## Land Use Application Updates (per 2/28/23 email)

LAND USE APPLICATION  
3/10/2023

1 ZONE C LAYOUT/MATERIALS  
1" = 20'-0"

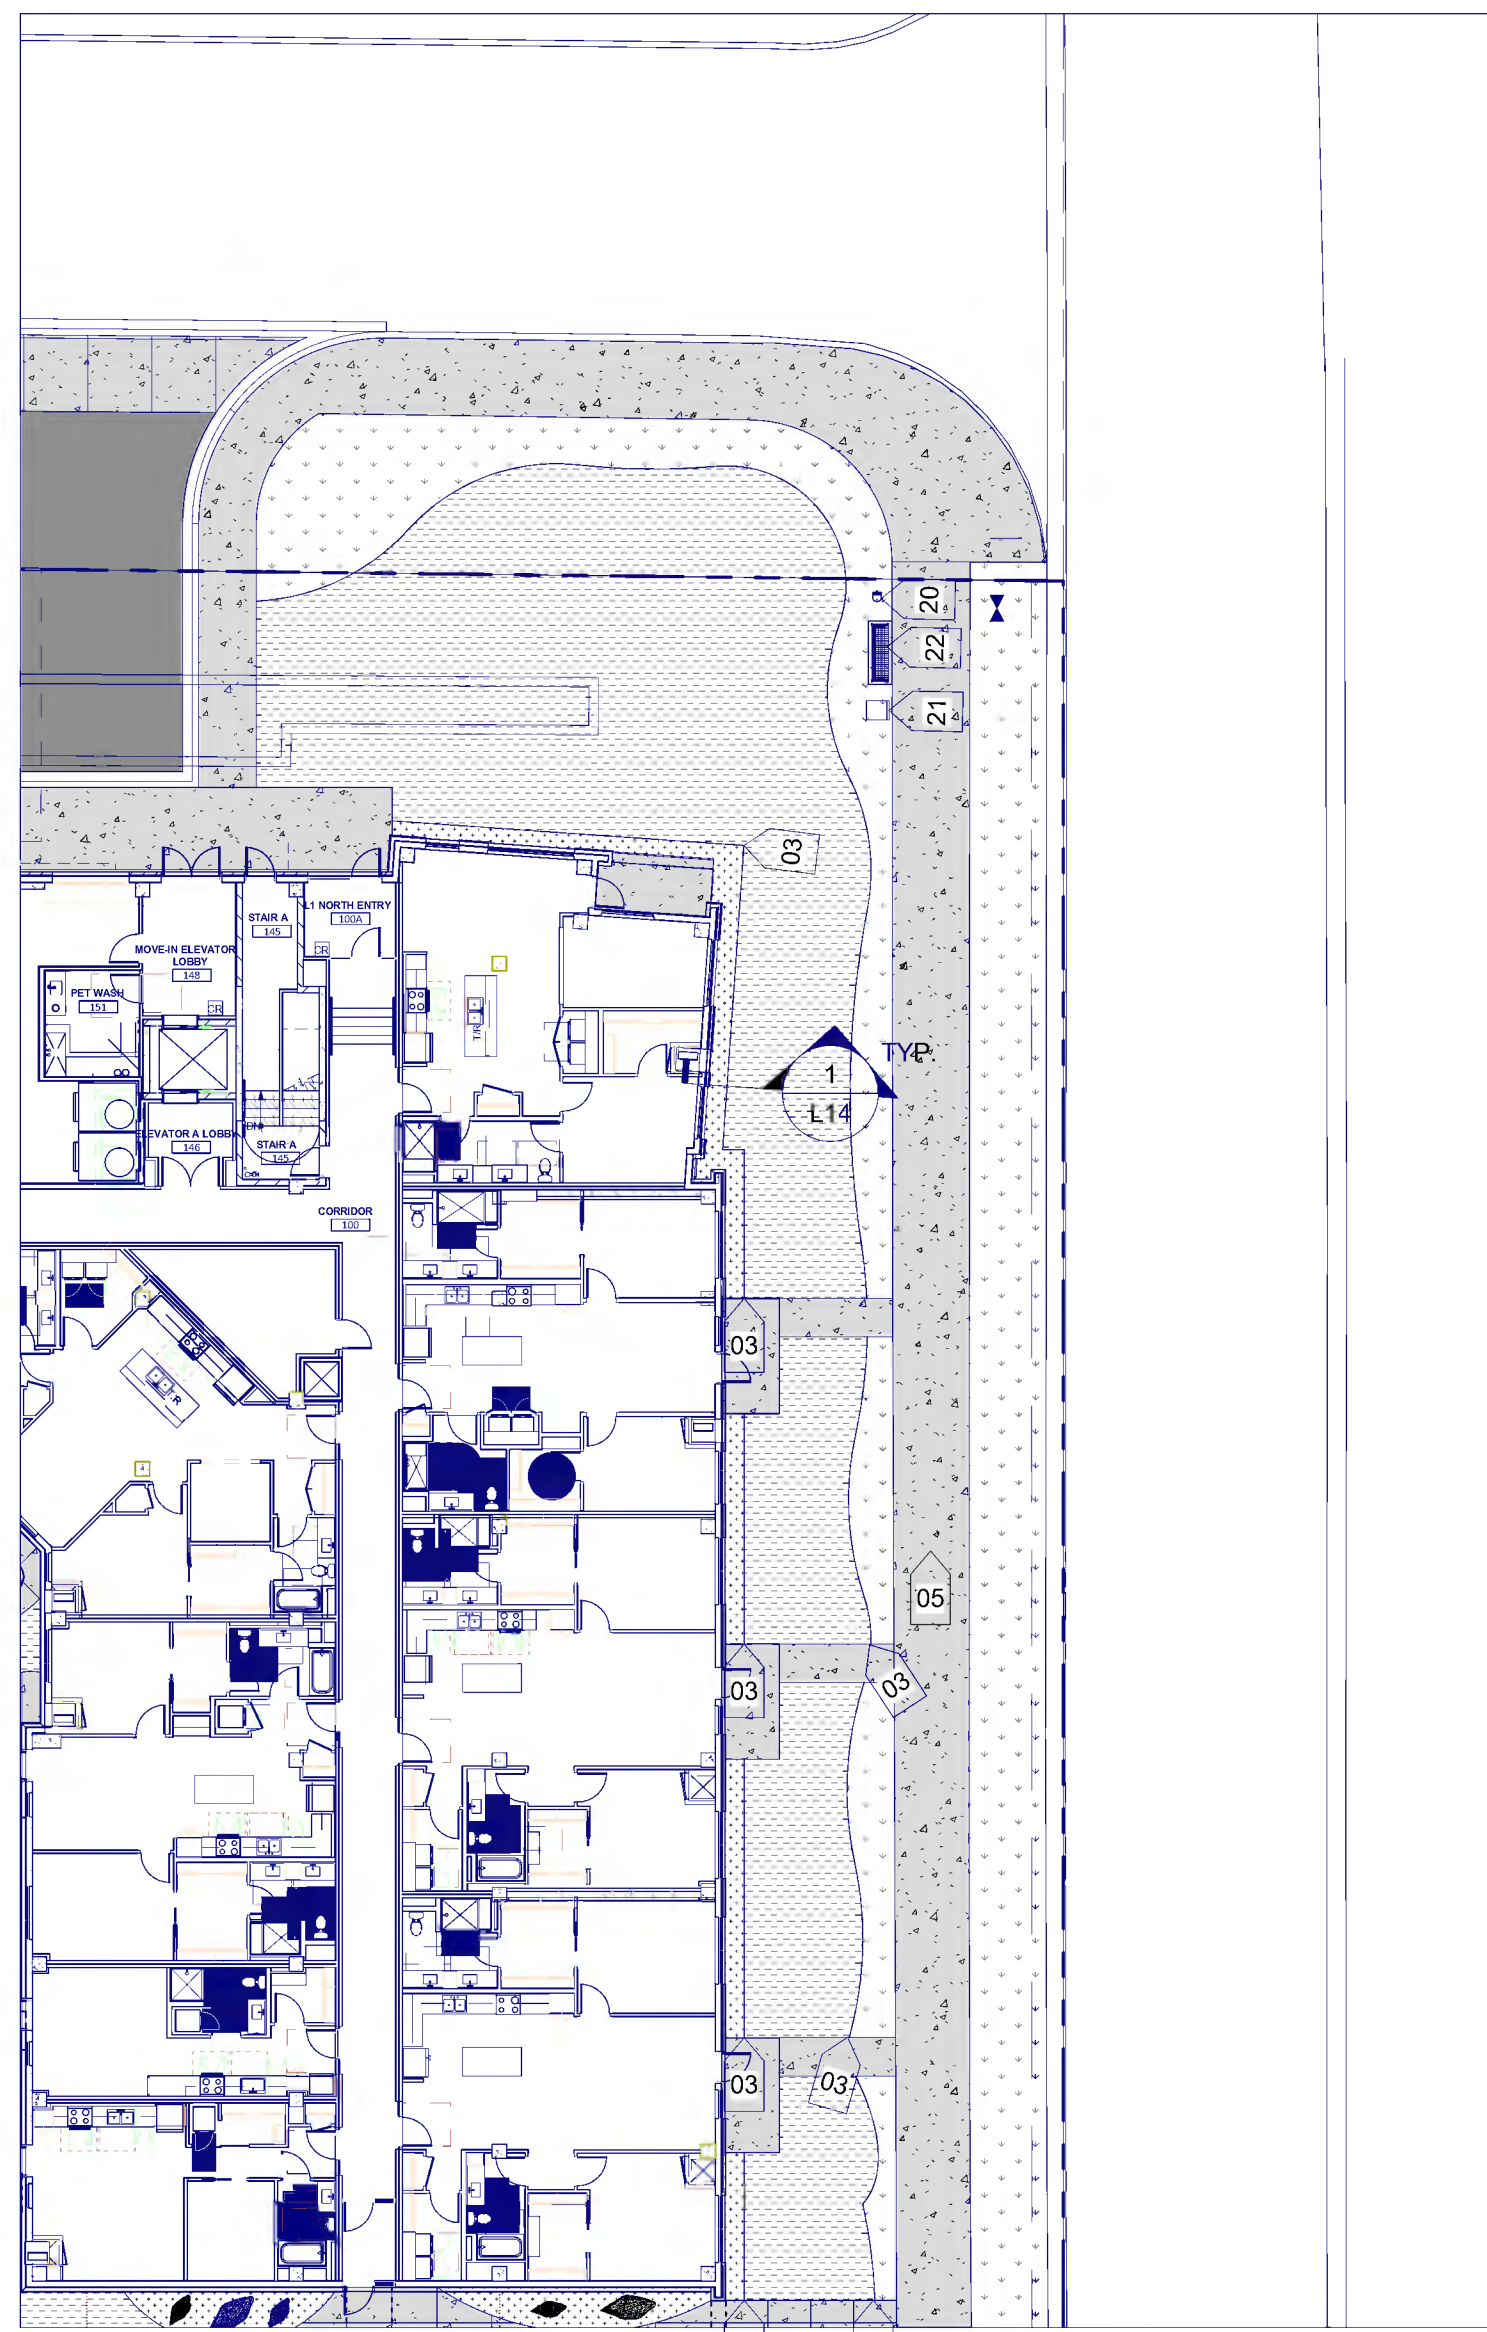
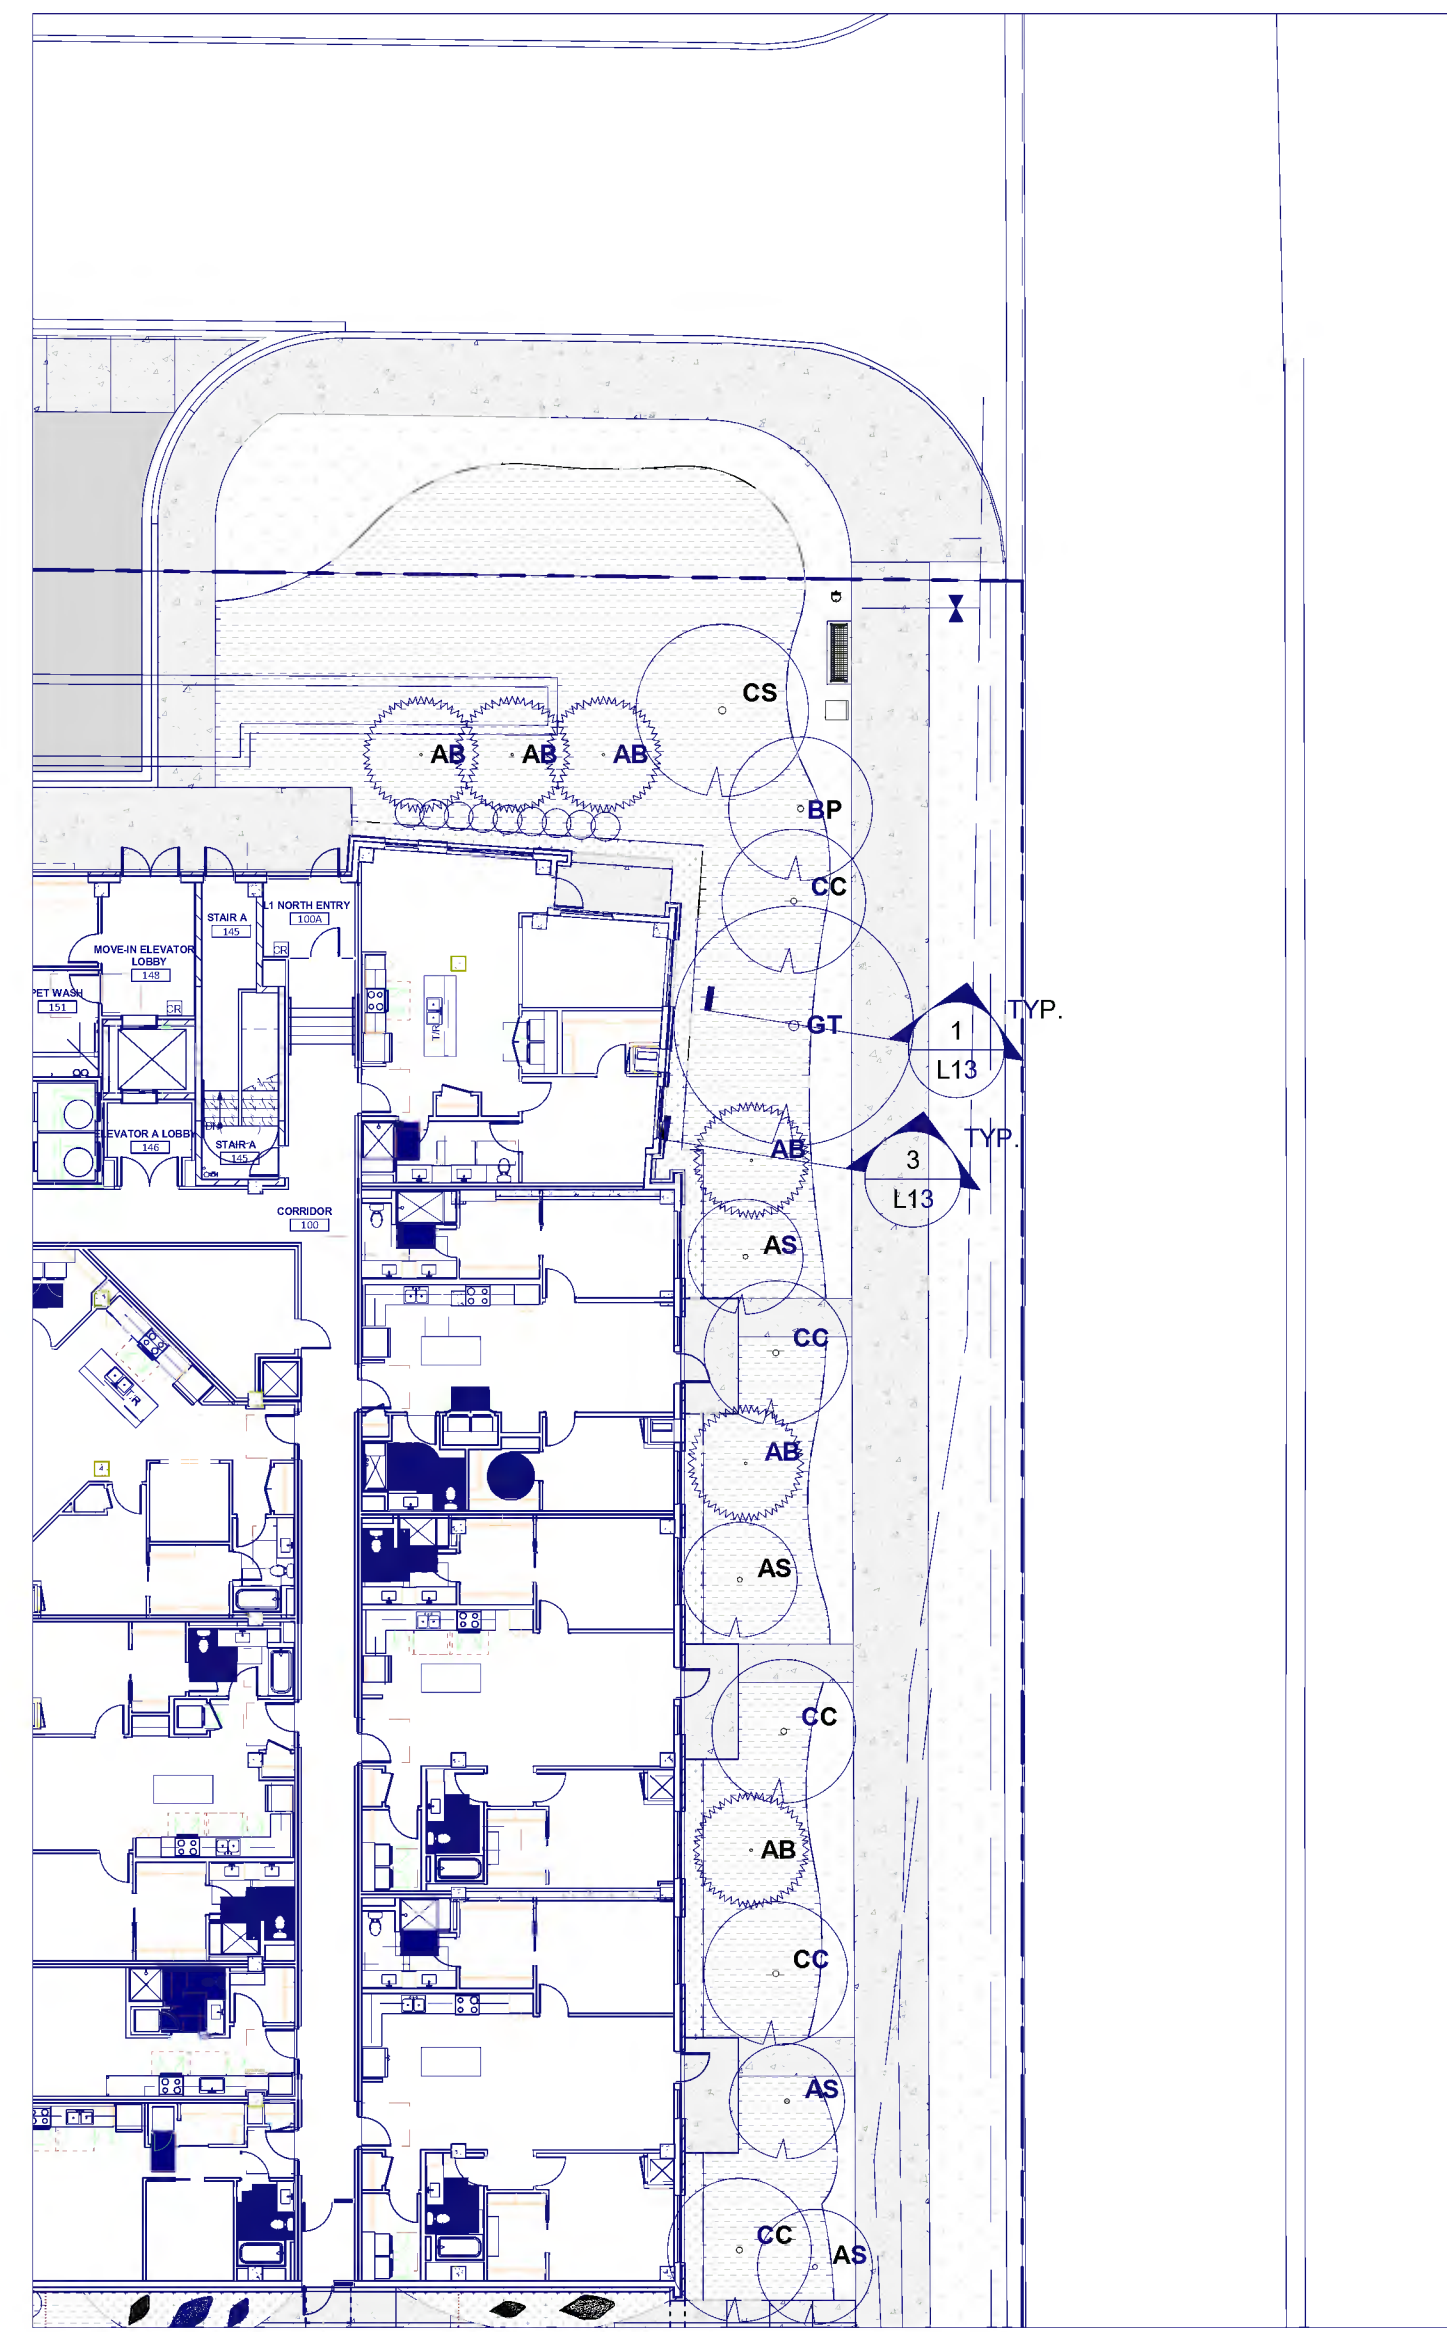
The plan must also incorporate pedestrian furniture, wayfinding signage from the Opus placemaking guide and dog waste bags. See top exhibit of L3 sheet, left exhibit of L4 sheet, and left exhibit of L5 sheet.
